County File No.: PLN2010-00093

Exhibit No. 1  
A-2-SMC-11-010 (Fitzgerald Marine Reserve)  
Final Local Action Notice  
Page 1 of 13

On January 12, 2011, the San Mateo County Planning Commission approved a Coastal Development Permit (CDP) and a Mitigated Negative Declaration (MND) for PLN 2010-00093: Fitzgerald Marine Reserve improvements to the Dardenelle Trail/California Coastal Trail between North Lake Street and Cypress Avenue in Moss Beach, San Mateo County.

**DARDENELLE TRAIL LOOKING TOWARD OCEAN  
FROM ABOUT 50' PAST OLD ROAD THAT GOES TO OCEAN TRAIL**

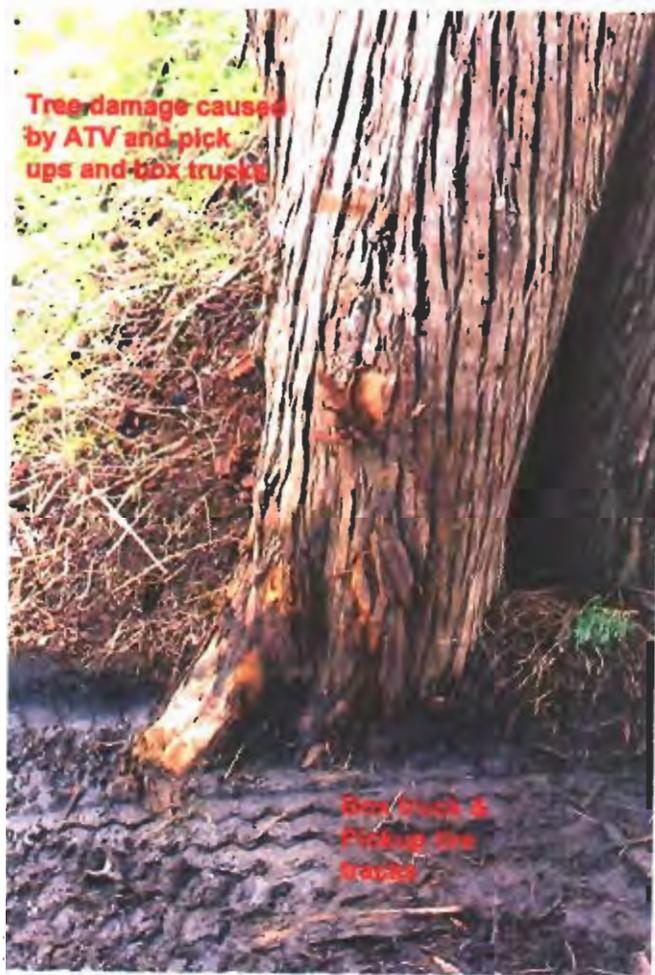
Though the path is proposed to be 8' wide in some place it is wider. Shoulders are required in certain places in order to prevent the path from being undermined by rain water. It is not clear to me where these shoulders are to be place or how many linear feet of shoulder there is going to be. This detail, which I think is significant should be called out in the design so that people can comment on it.

**WHAT  
PARKS DEPT  
PROPOSES -  
AN 8' WIDE PATH  
WITH SHOULDERS  
IN AREAS OF SLOPE  
A TAN COLOR WAS ONE  
PROPOSED. WE DON'T  
THINK IT FITS WELL.**

Figure 2: Trail Structure Terminology

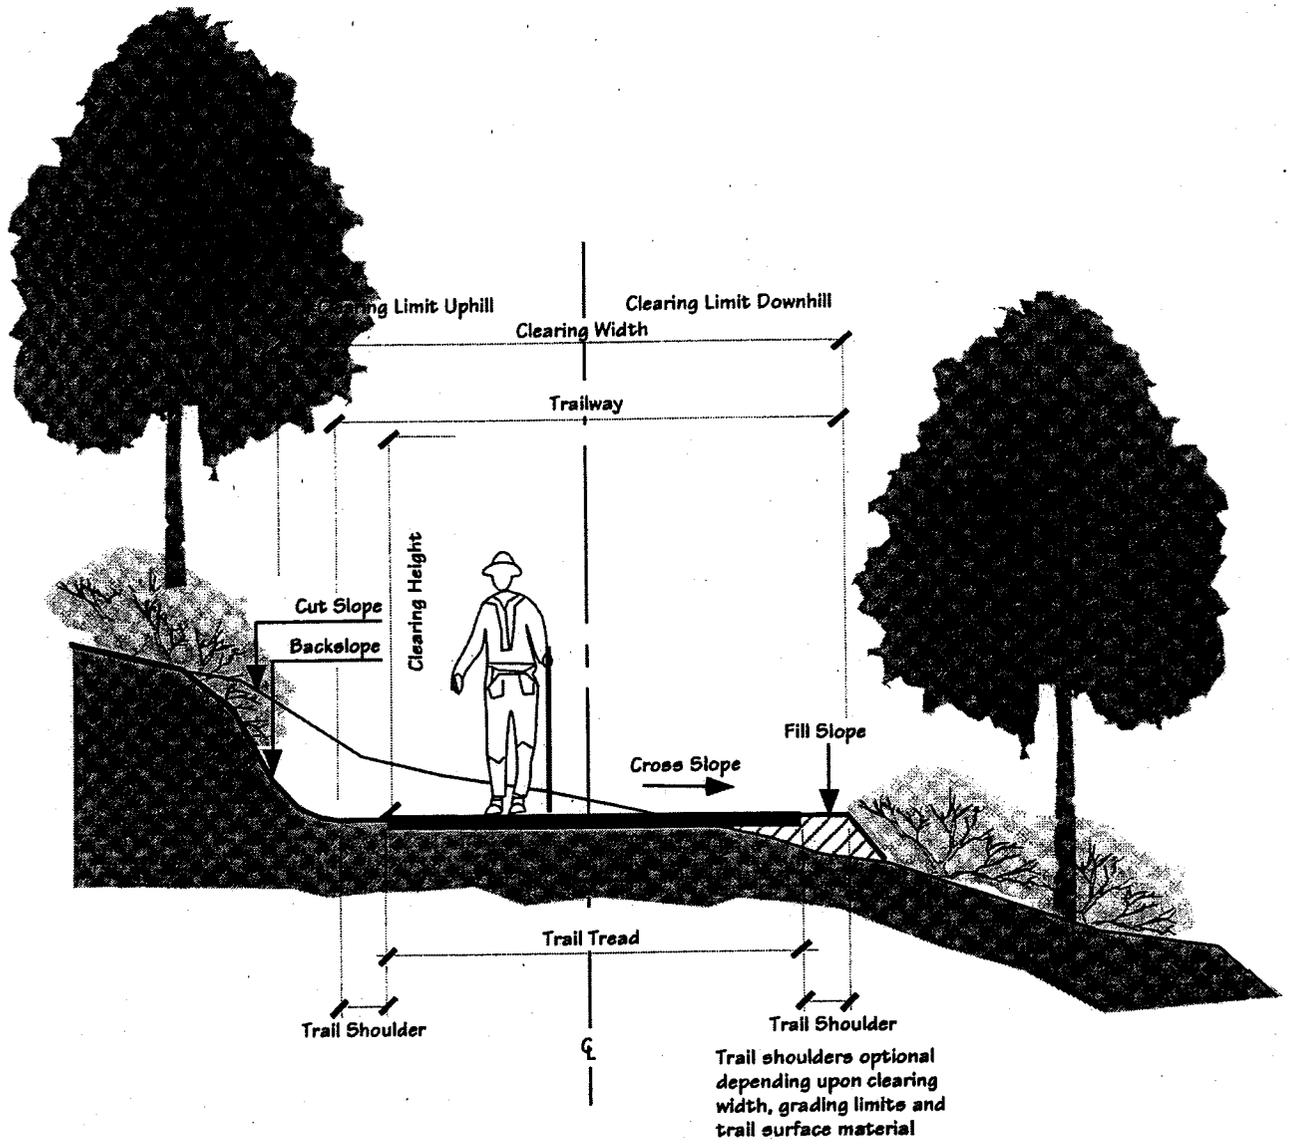
Also, as per our conversation yesterday, could you give me a brief outline of what unimproved shoulder means? And could we clarify that even though it is shown on the map to be throughout the project, it will most likely only be at that portion which you pointed out in the site visit - that grades into the hill?

That is correct. No improved shoulders but fill slope where necessary to hold up the trail where graded into the hillside to achieve 5% ADA slope. See attached graphic from County Trail Plan regarding trail structure terminology.
